# Service Bulletin

Ref. No. **2ND-0148 (J212)**

<b>Subject:</b>	<b>Corrective measures for the high frequency sound from the main high voltage PWB (For service parts only)</b>		
<b>Model:</b>	<b>TASKalfa 2552ci, TASKalfa 3252ci, TASKalfa 2553ci, TASKalfa 3253ci, TASKalfa 2554ci, TASKalfa 3554ci</b> <b>(--&gt;)TASKalfa MZ2501ci, TASKalfa MZ3501ci</b>		
<b>Classification:</b>	<b>Field measures timing:</b>	<input type="checkbox"/> At Set Up <input checked="" type="checkbox"/> Next Visit/Service Call	<input type="checkbox"/> Next Periodic Maintenance <input type="checkbox"/> Information only
	<b>Phenomenon:</b>	<input type="checkbox"/> SC/Error <input type="checkbox"/> Image	<input type="checkbox"/> Paper Feeding/Conveying <input type="checkbox"/> Machine operation <input checked="" type="checkbox"/> Other
	<b>Type of change:</b>	<input checked="" type="checkbox"/> Hardware <input type="checkbox"/> Firmware and Software	<input type="checkbox"/> Information

## [Main high voltage PWB]

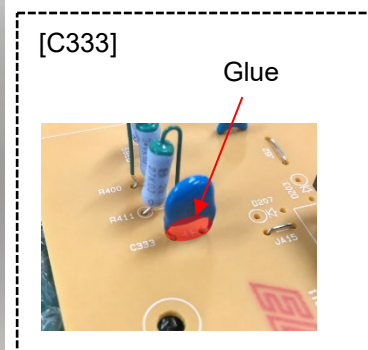
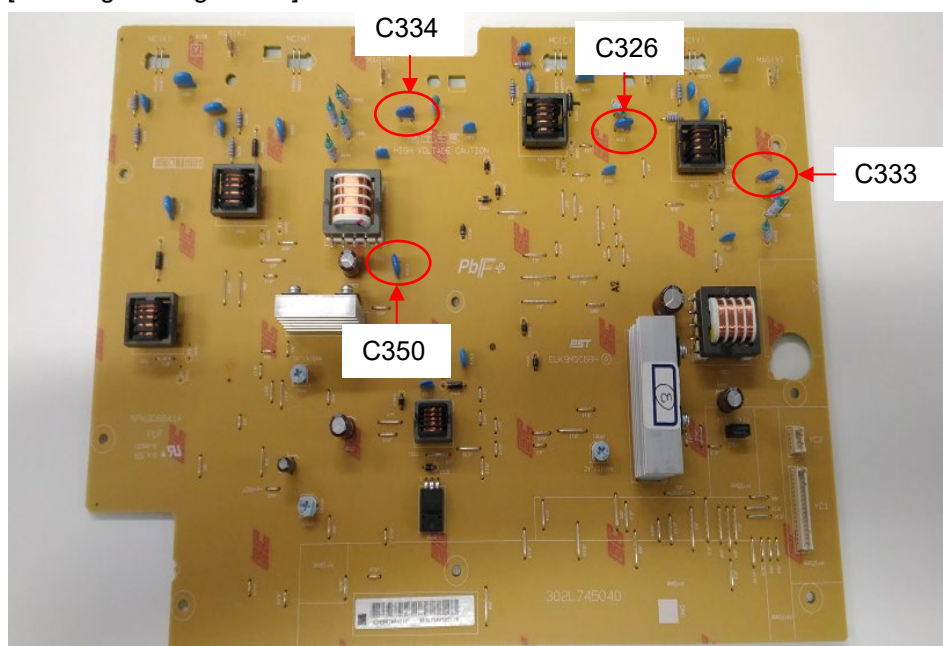
High frequency sound might occur from the capacitors (C333, C334, C326, C350) on the main high voltage PWB in the timing below depending on variation of parts and the main high voltage PWB for service (No1) is changed as follows.

The gap between the capacitor and PWB is filled with glue to regulate the vibration of the capacitors (C333, C334, C326, C350) \*This change is only applied to the main high voltage PWB for service.

**Field Measure:** Replace with the new main high voltage PWB (No1) when the above phenomenon occurs. (Refer to Chapter 4 of the service manual [Detaching and reattaching the main high voltage PWB])
